Memo

Re: Ordinance 100-14 – Rezoning Approximately 2.9 Acres, Located on the North Side of Perimeter Drive, Between the Intersections with Avery-Muirfield Drive and Hospital Drive, From PUD, Planned Unit Development District (Riverside PCD North, Subarea A3) to PUD, Planned Unit Development District (Riverside PUD North, Subarea A3) to Facilitate the Development of a Coffee Shop with a Drive-thru. (Case 14-069Z/PDP/FDP)

14-069Z/PDP/FDP/CU
Rezoning/Preliminary Development Plan/
Final Development Plan/Conditional Use
Riverside PCD North, Subarea A3 - The Perimeter Starbucks
6510-6570 Perimeter Drive

STARBUCKS
COFFEE

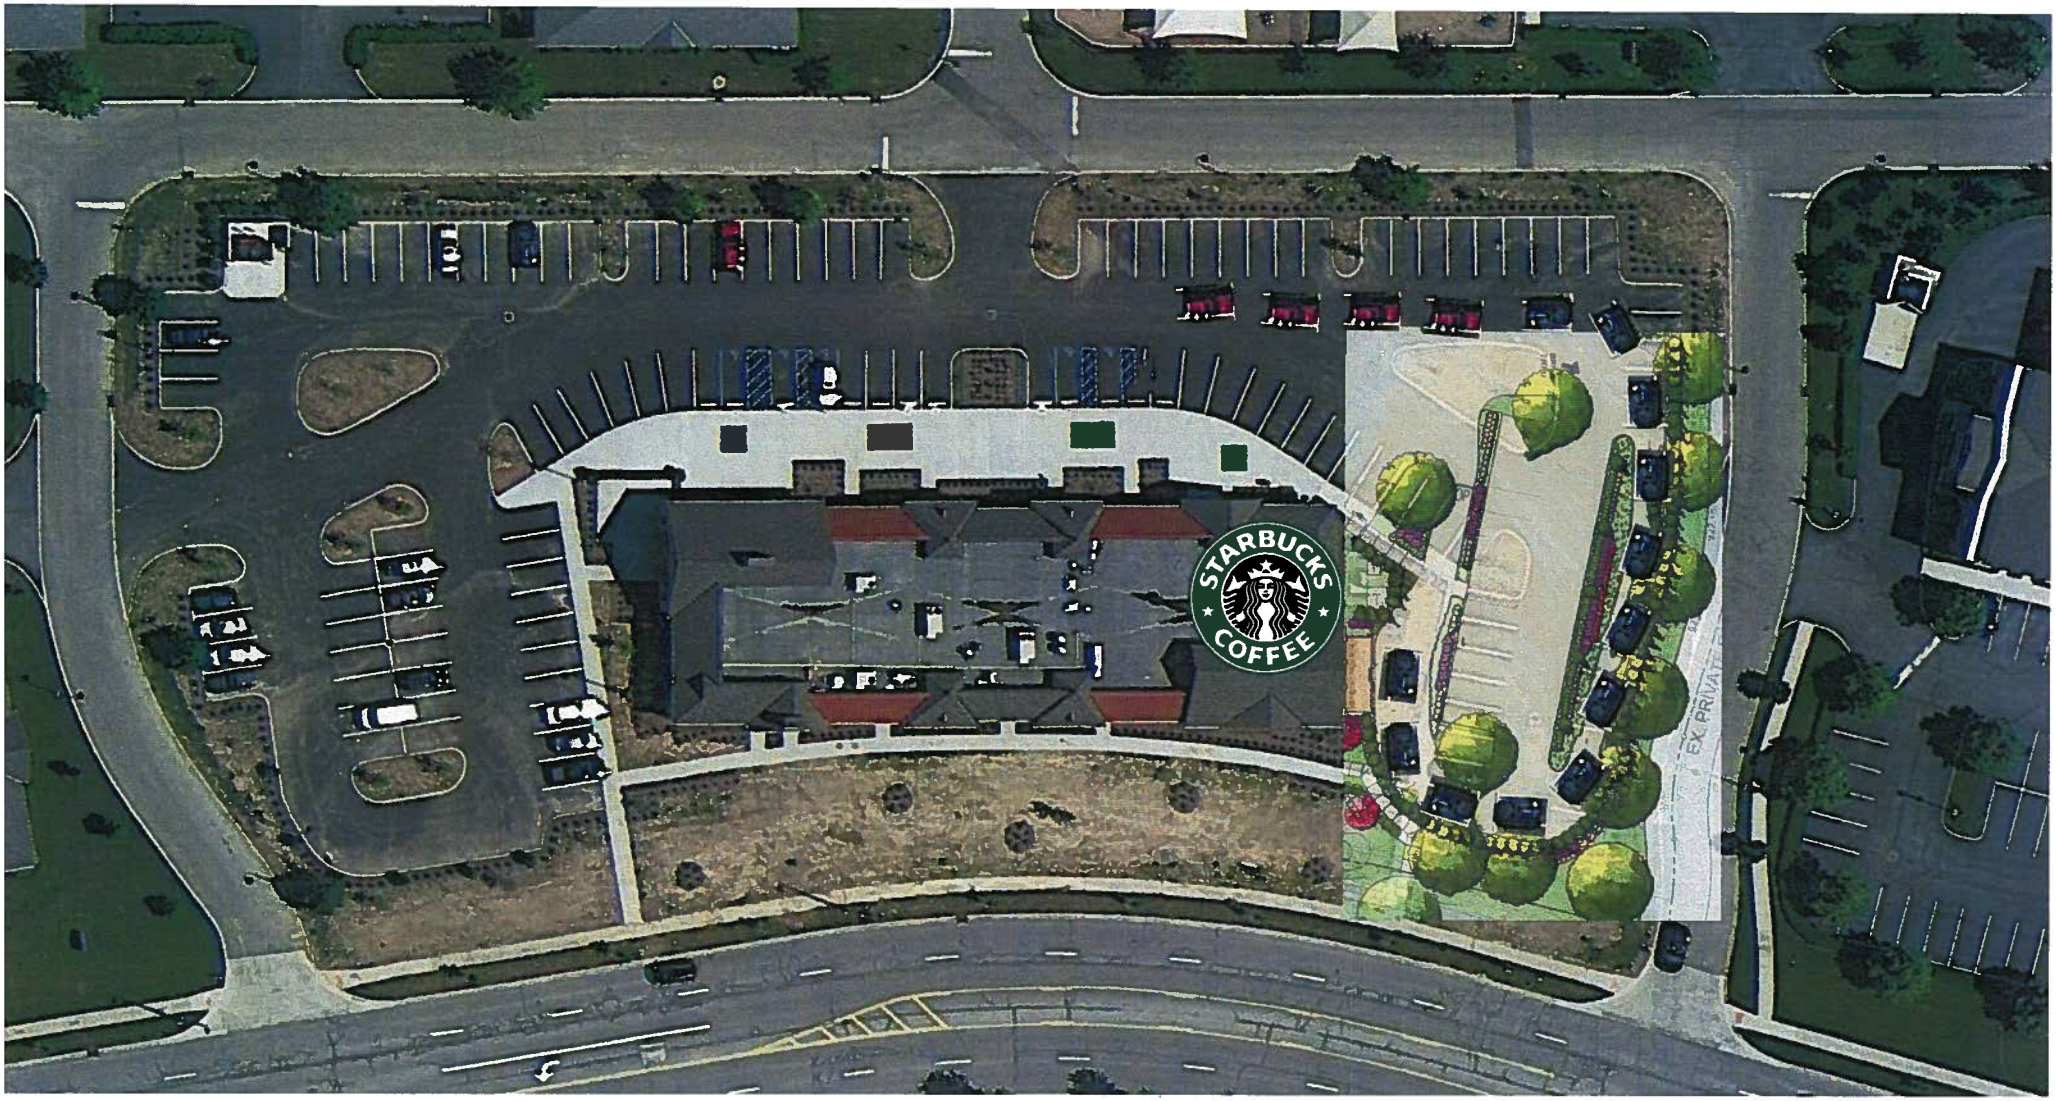
Council members were concerned with the proposed stacking and circulation of the drive-thru and requested additional information regarding the stacking of other existing area drive-thrus. The following information was collected by Planning.

The applicant for Starbucks has provided graphics (attached to this memo) illustrating the 12 stacked vehicles (shown in blue) in the proposed drive-thru for Starbucks and an additional four vehicles (in red) all stacked within the site. Similar graphics include Tim Horton's and McDonald's on Perimeter Drive. Both graphics for these restaurants show that vehicles are forced to stack off-site at around 11 cars in the drive-thru and that any vehicles beyond that number are forced to stack off-site.

The applicant has also indicated a willingness to require employees of Starbucks to park in the northeastern parking aisle to avoid the potential for customers being blocked by additional stacking.
